Access Compliance Report Public Rights-of-Way (Curb Ramps)

Main Street: PROSPECT_AVE Cross Street: ARBOLADA_WAY Location: NE

ADA ID: RPRK211011124200 Ramp Type: Type 1 - Perpendicular Diagonal Initial Pass/Fail: Fail Overall Compliance: No Severity Score: 16

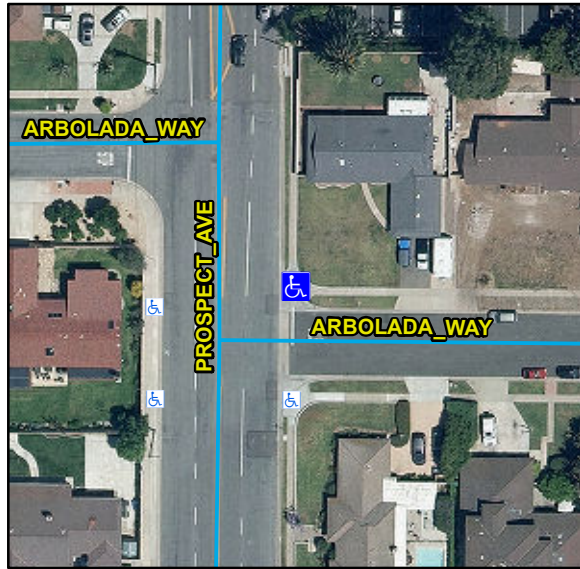
Compliance	Description	Data	Compliance	Description	Data
N/A	Ramp Length (in)	96	N/A	Flare Type LT	
Yes	Ramp Width (in)	48			N/A
No	Ramp Run Slope (%)	10	N/A	Flare Slope LT (%)	N/A
No	Ramp Cross Slope (%)	2.3	N/A	Flare Traversable LT	N/A
N/A	Landing Present	N/A	N/A	Flare Type RT	
N/A	Landing Length (in)	N/A			N/A
N/A	Landing Width (in)	N/A	N/A	Flare Slope RT (%)	N/A
N/A	Landing Run Slope (%)	N/A	N/A	Flare Traversable RT	N/A
N/A	Landing Cross Slope (%)	N/A	N/A	DWS Provided	N/A
N/A	Landing Movement Obstructed?	N/A	N/A	DWS Contrast	N/A
	Landing Movement Type	N/A	N/A	DWS Length (in)	N/A
N/A	Landing Shared	N/A	N/A	DWS Full Width	N/A
N/A	Clear Space	Yes	N/A	DWS Offset Left (in)	N/A
N/A	Clear Space To Crosswalk (in)	N/A	N/A	DWS Offset Right (in)	N/A
N/A	Marked Crosswalk 1	No	N/A	Marked Crosswalk 2	No
	Crossing 1 Direction	W		Crossing 2 Direction	S
	Marked Crosswalk 1 Width (in)	N/A		Marked Crosswalk 2 Width (in)	N/A

N/A	Ramp Inside Crosswalk 1	N/A	Yes	Ramp Inside Crosswalk 2	N/A
	Crossing 1 Slope (%)	11.5		Crossing 2 Slope (%)	2.1
	Crossing 1 Cross Slope (%)	1.9		Crossing 2 Cross Slope (%)	1.1
N/A	Gutter Ponding	N/A	No	Curb Slope	13.9
Yes	Gutter Lip Height (in)	0		Road Run Slope (%)	2
N/A	Gutter Run Slope (%)	N/A		Road Cross Slope (%)	6.4
N/A	Gutter Cross Slope (%)	N/A			
Yes	Overall Surface Condition: Acceptable		Yes	Perp Joint Present	Yes
	Cross Gutter Present?	Yes		Spandrel Present?	Yes
	Replace Cross Gutter?	No		Replace Spandrel?	No

Remove & Replace Curb Ramp With Two New Directional Ramps or Equivalent.
